STAFF REPORT
KETCHUM PLANNING AND ZONING COMMISSION
MEETING OF APRIL 23rd, 2024

PROJECT: Warm Springs Preserve Building

FILE NUMBER: P23-104

APPLICATION: Design Review

C3.0

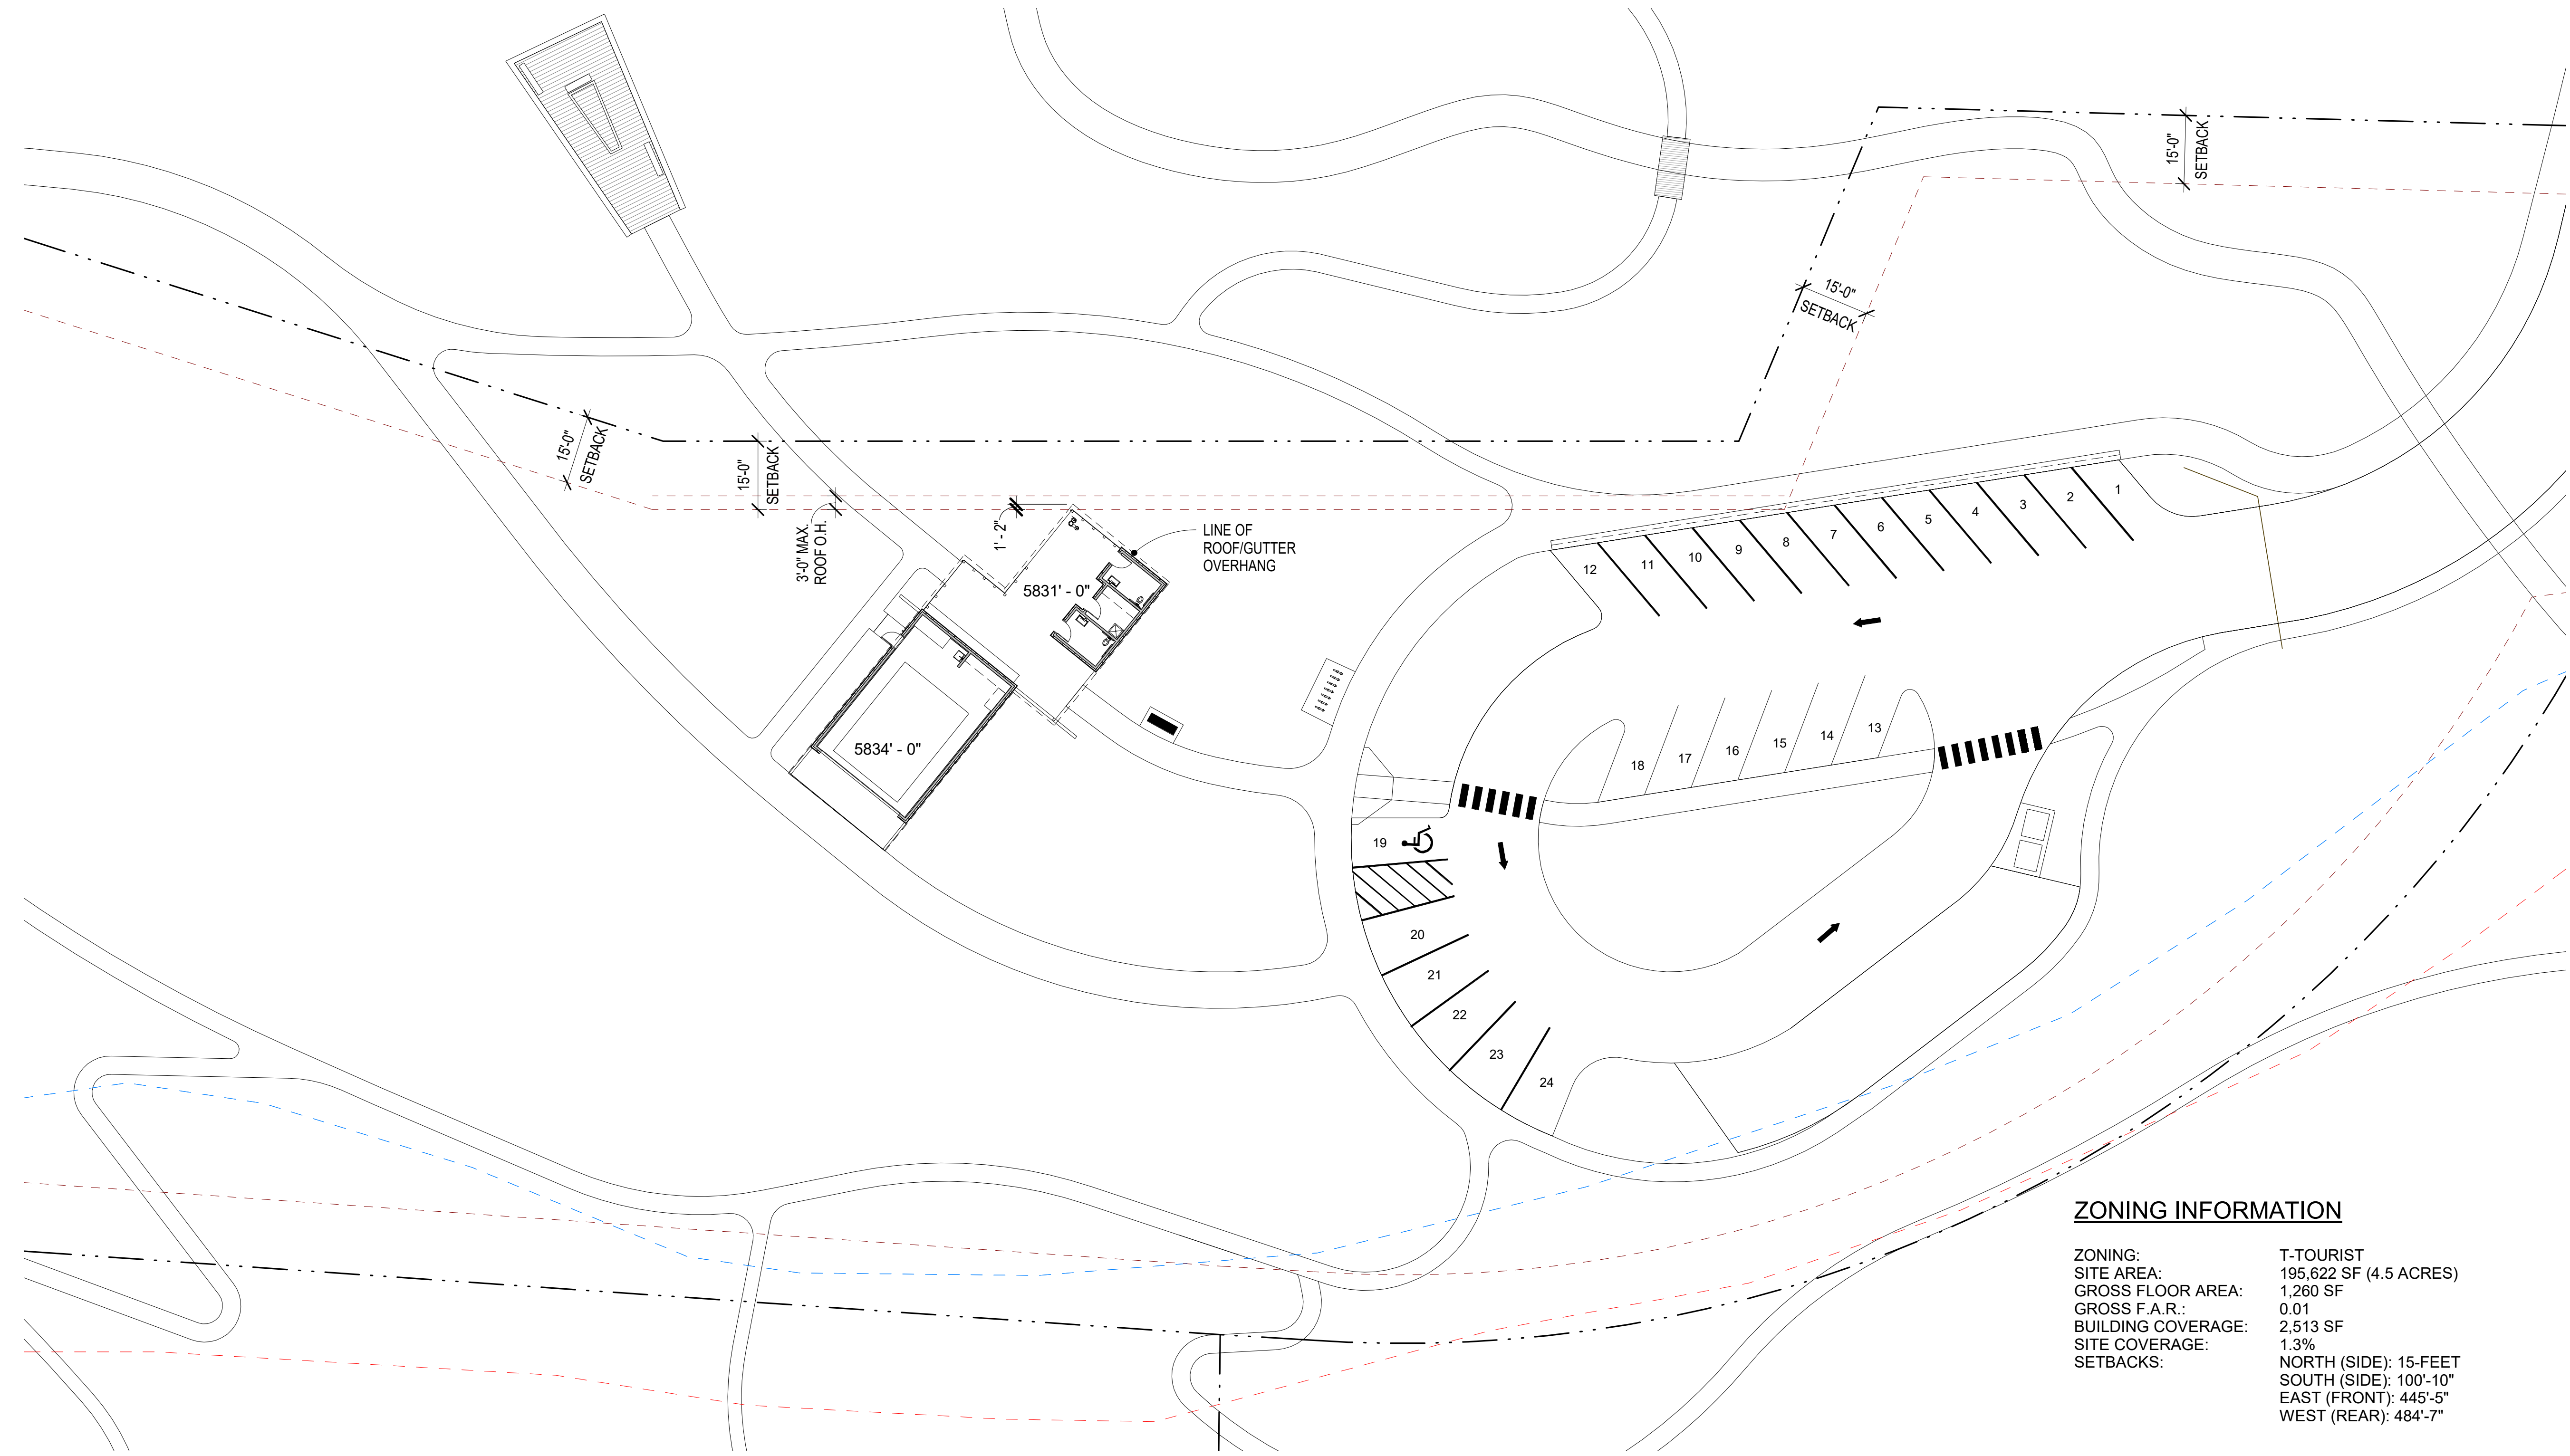
| 17.96.060.D.2 - Utilities | Conformance |
|--|-------------|
| Finding: As shown on Sheet C3 of the project plans, the applicant proposes connecting to the municipal water and sewer systems from existing lines on Irene St. Requirements and specification for the water and sewer connections will be verified, reviewed, and approved by the Utilities Department prior to issuance of a Building Permit. | |

PERCENTAGE OF SNOW STORAGE AREA: 32.3%

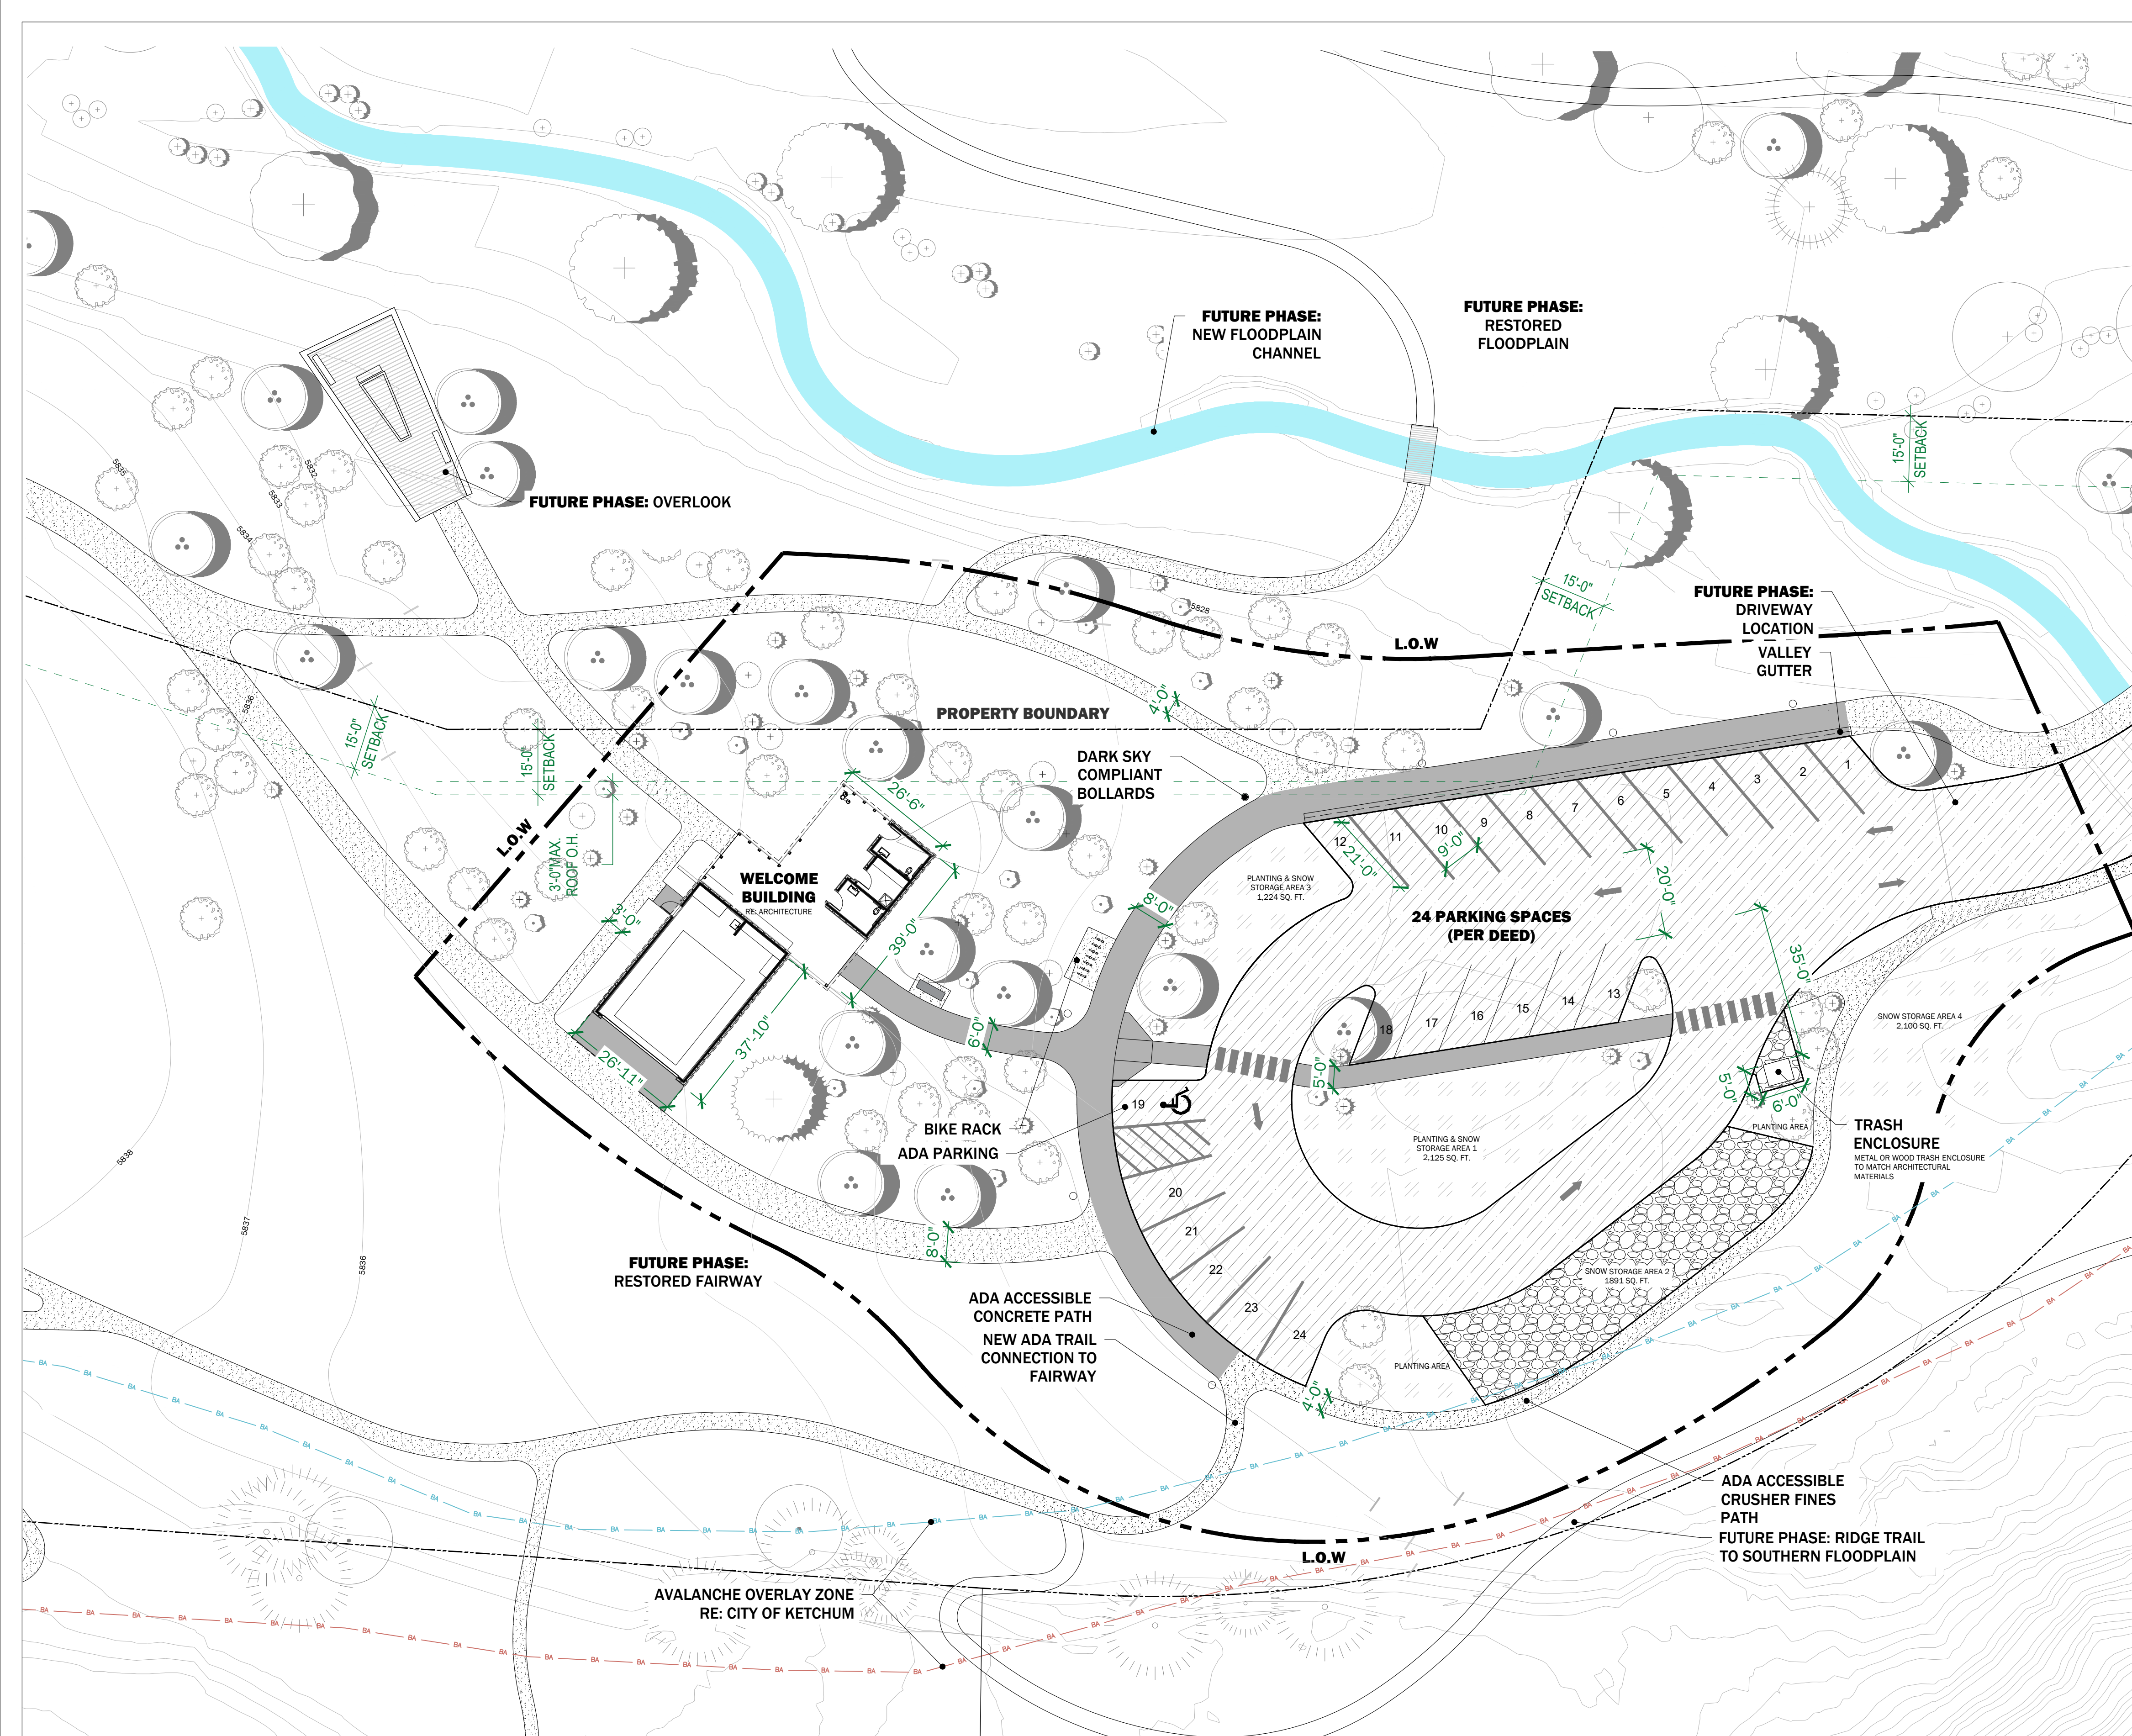
| 17.96.060.H.1 – Snow Storage | Conformance |
|--|-------------|
| Finding: Sheet L1.02 shows the proposed snow storage areas to include a total of 7,692 square feet, greater than the required 30% (23,810 * .30 = 7,143 square feet). | |

| 17.96.060.H.2 – Snow Storage | Conformance |
|---|-------------|
| Finding: The location of the snow storage area is indicated on Sheet L1.02 of the project plans. | |

| 17.96.060.H.3 – Snow Storage | Conformance |
|--|-------------|
| Finding: The snow storage areas for the proposed project do not have dimensions less than five feet as seen on Sheet L1.02. | |
